Stop Work

Stop work order  
FBC 5th Edition Building 115.1

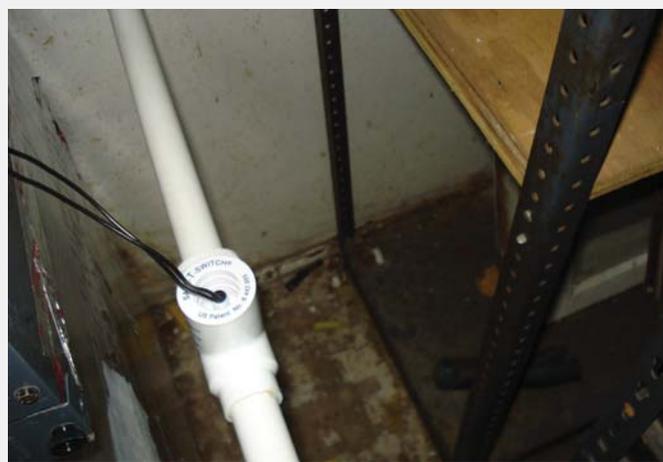
Main return air box-FBC 5th Edition Residential M1601.4.1  
FBC 5th Edition-Mechanical 603.9

Main return air box-FBC 5th Edition Residential M1601.4.1  
FBC 5th Edition-Mechanical 603.9

Master supply air-FBC 5th Edition Residential M1601.4.1  
FBC 5th Edition-Mechanical 603.9

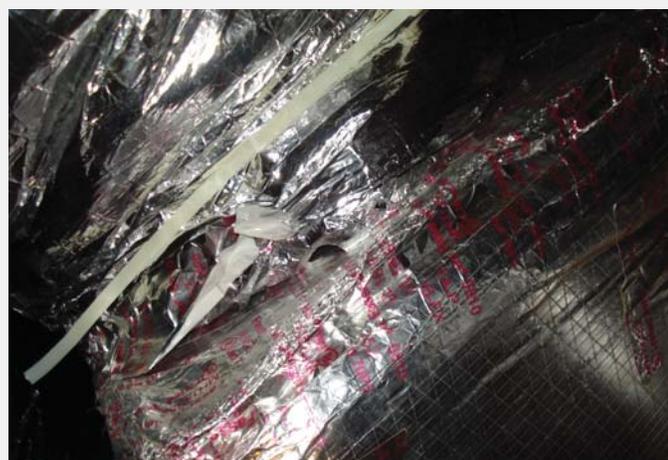
Drain line not insulated or supported  
FBC 5th Edition Mechanical 307.2.5

Drain line not insulated or supported  
FBC 5th Edition Mechanical 307.2.5

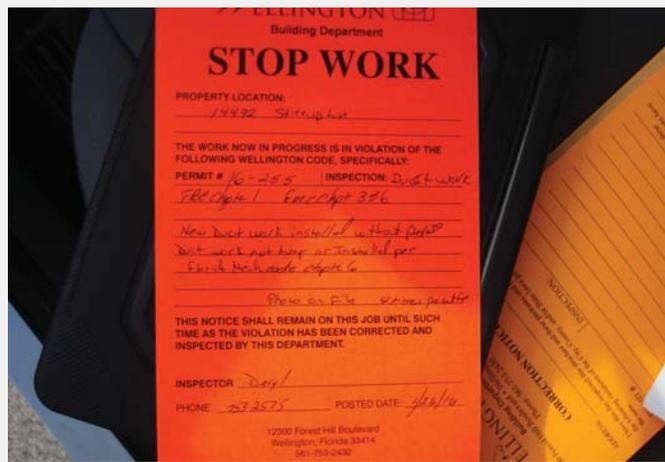
Flex duct not supported properly  
FBC 5th Edition Mechanical 603.10

Flex duct not supported properly  
FBC 5th Edition Mechanical 603.10
